REAR BRAKE MASTER CYLINDER PISTON / 1979 MODELS

In compliance with the National Traffic and Motor Vehicle Safety Act, this has been declared a safety defect by Harley-Davidson Motor Co., Inc., and the affected motorcycles within the following range of VIN's must be corrected as soon as possible by installing the proper master cylinder piston:

INSTRUCTIONS FOR REPLACING PARTS (See Illustration)

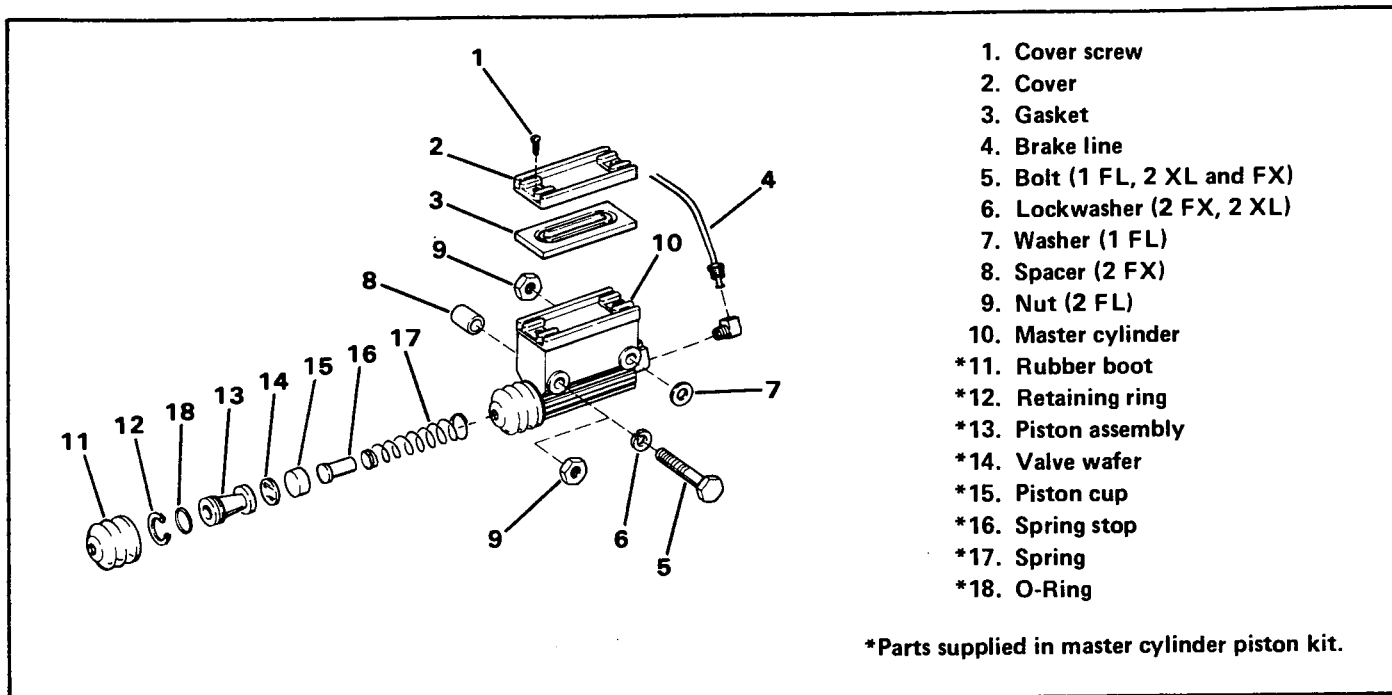
A quantity of 1979 model 1200/1340 and 1000cc motorcycles were assembled and shipped with master cylinder pistons made from an incorrect material as received from our supplier.

The incorrect material may allow water absorption to a greater degree than the correct material specified by Harley-Davidson. A plastic piston made of this incorrect material, in isolated instances, might stick in the master cylinder piston bore. This condition would most likely come on gradually as the piston absorbs moisture and swells. If this sticking occurs, the brake may not fully release and will have a tendency to drag. If the motorcycle operator does not heed this prior warning, it is possible, though extremely unlikely, that this condition may become severe enough to make the rear wheel skid, or a dragging brake may generate enough heat to make the brake fluid boil causing an ineffective brake. Either of these conditions could cause the motorcycle operator to lose control.

All Models: Remove rubber boot (11), retaining ring (12), piston assembly (13), wafer (14), piston cup (15), spring stop (16) and spring (17).

Reassemble master cylinder using new parts from kit (marked with asterisk * in illustration). Dip all parts in new DOT 5 brake fluid and assemble in order shown with O-ring installed in groove on piston.
